UNITED STATES
DEPARTMENT OF THE INTERIOR
BUREAU OF LAND MANAGEMENTNM OIL CONSERVATION
ARTESIA DISTRICTJUN 30 2014
OCD ArtesiaFORM APPROVED
OMB NO. 1004-0135
Expires: July 31, 2010**SUNDRY NOTICES AND REPORTS ON WELLS**
Do not use this form for proposals to drill or to re-enter an abandoned well. Use form 3160-3 (APD) for such proposals.

1. Type of Well <input checked="" type="checkbox"/> Oil Well <input type="checkbox"/> Gas Well <input type="checkbox"/> Other		5. Lease Serial No. NMNM82896
2. Name of Operator OXY USA INCORPORATED		6. If Indian, Allottee or Tribe Name
Contact: DAVID STEWART E-Mail: david_stewart@oxy.com		7. If Unit or CA/Agreement, Name and/or No.
3a. Address 5 GREENWAY PLAZA STE 110 HOUSTON, TX 77046-0521	3b. Phone No. (include area code) Ph: 432-685-5717 Fx: 432-685-5742	8. Well Name and No. NIMITZ 12 FEDERAL 4H
4. Location of Well (Footage, Sec., T., R., M., or Survey Description) Sec 12 T24S R30E SESW 100FSL 2033FWL 32.238481 N Lat, 103.853838 W Lon		9. API Well No. 30-015-41506-00-X1
		10. Field and Pool, or Exploratory POKER LAKE
		11. County or Parish, and State EDDY COUNTY, NM

OXY USA Inc. respectfully requests a variance to the approved APD for the follo

9-5/8" x 7" ANNULUS TEST

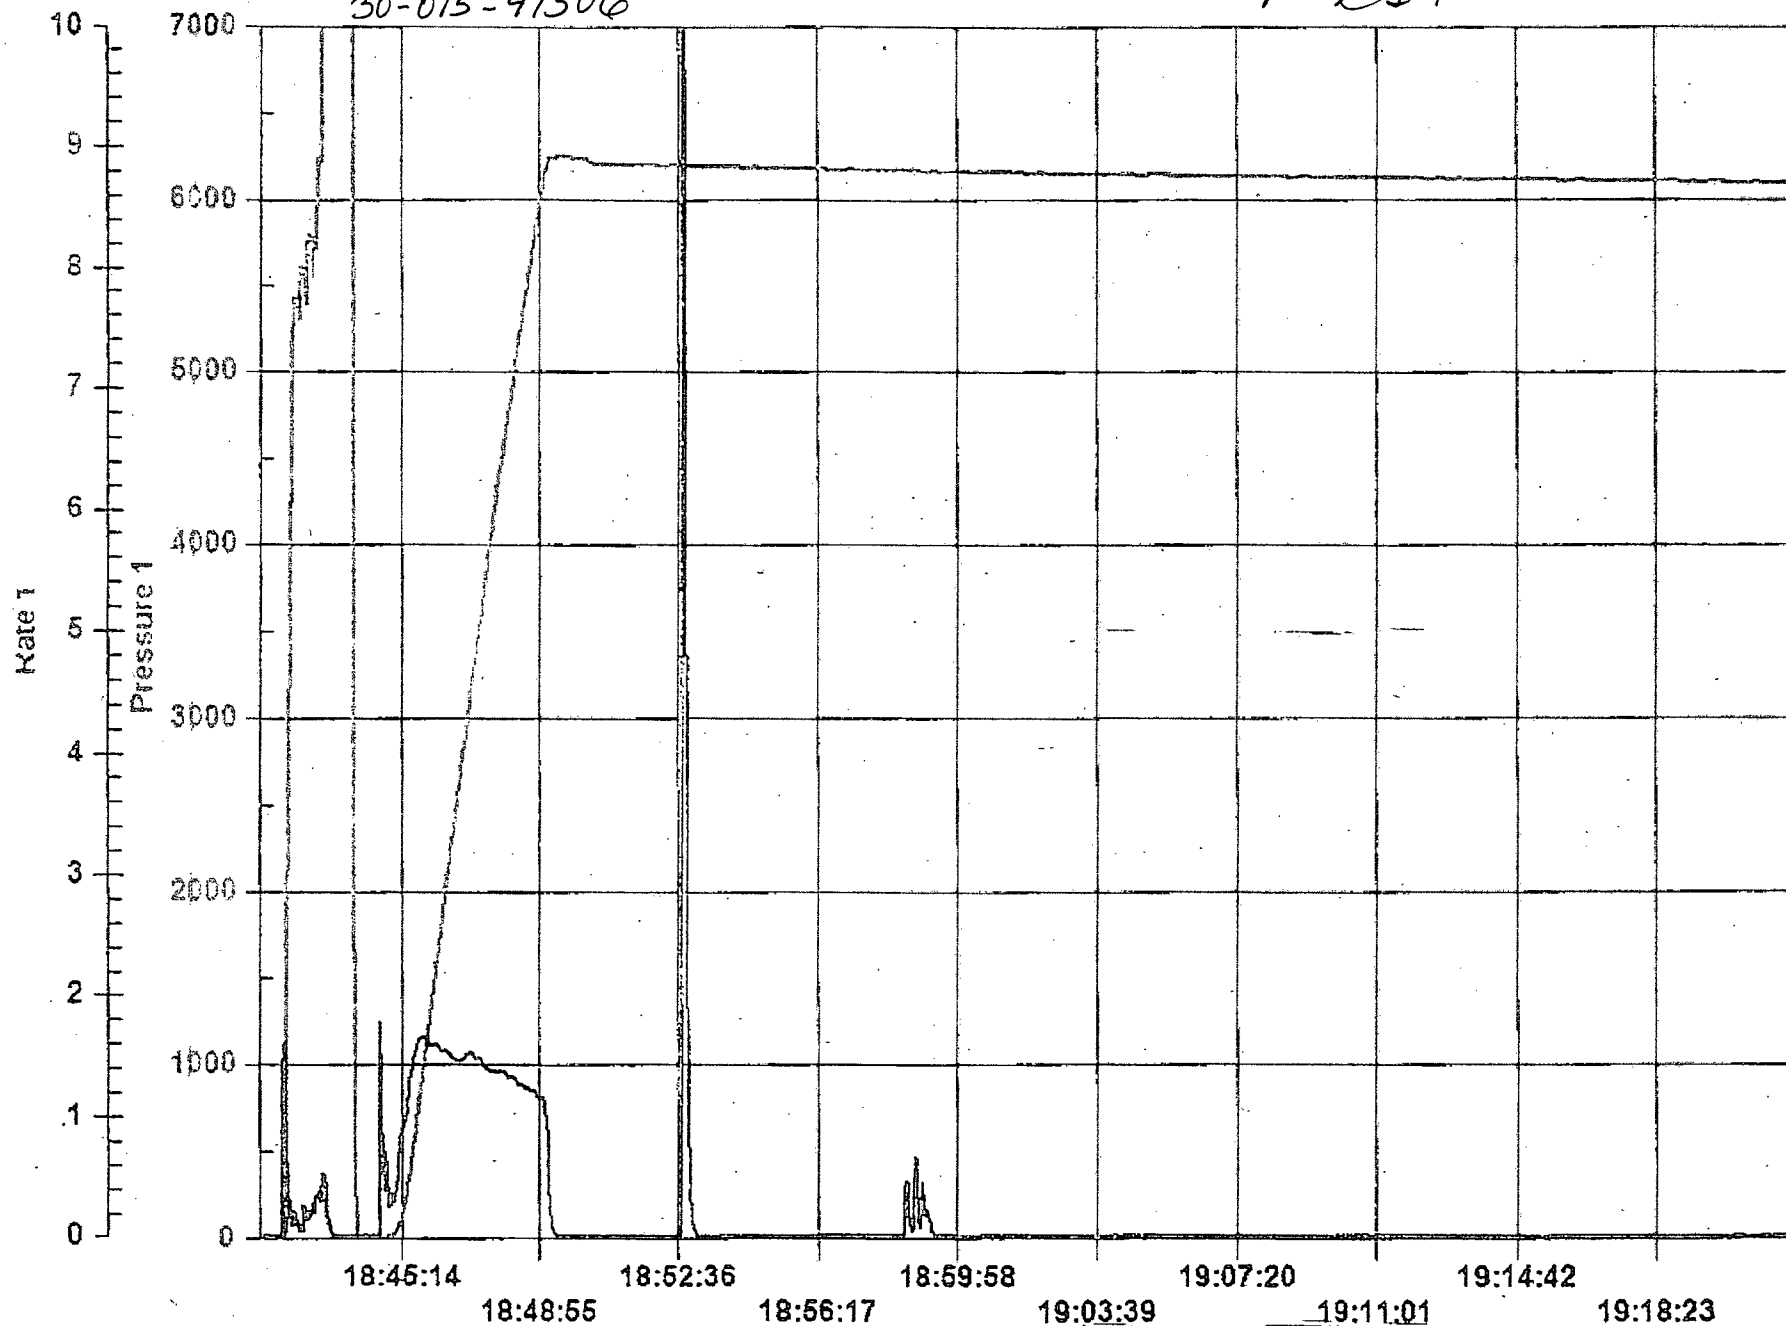
1. Production cement program adjustment to include actual TOC at ~610' based on CBL ran 6/18/14. Cement was circulated to surface during cementing job, see below for detail.
2. The 9-5/8" x 7" annulus was tested to 550psi for 30 minutes, testing chart attached.
